Certificate of non-objection

Gin Gliders Inc.

19.09.2024

1. WLE

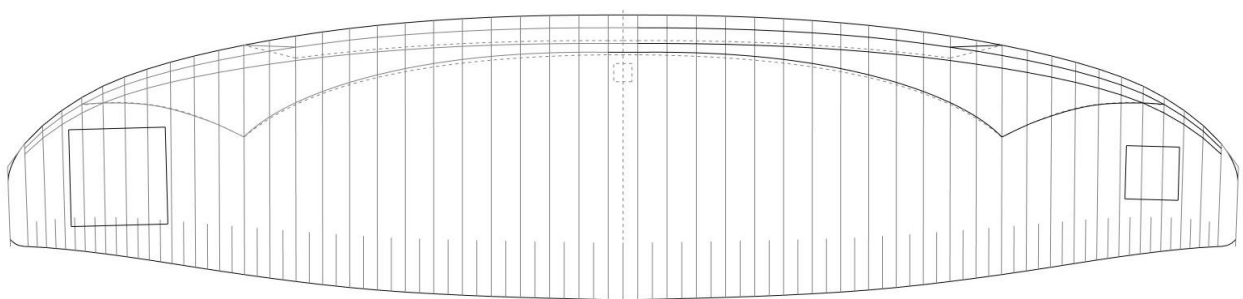
Fuse mini is equipped with the Wave Leading Edge at the front:

Fuse mini

Fuse 4

3. Extended bottom plastic rods

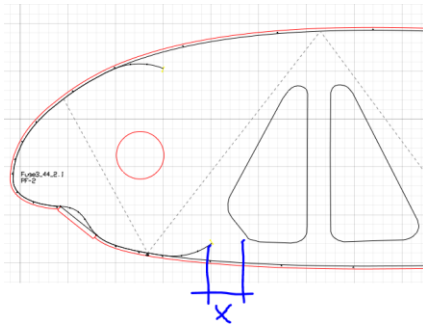
The length of the bottom plastic rods is extended about 7% (X value in drawing above, reference to chord length).
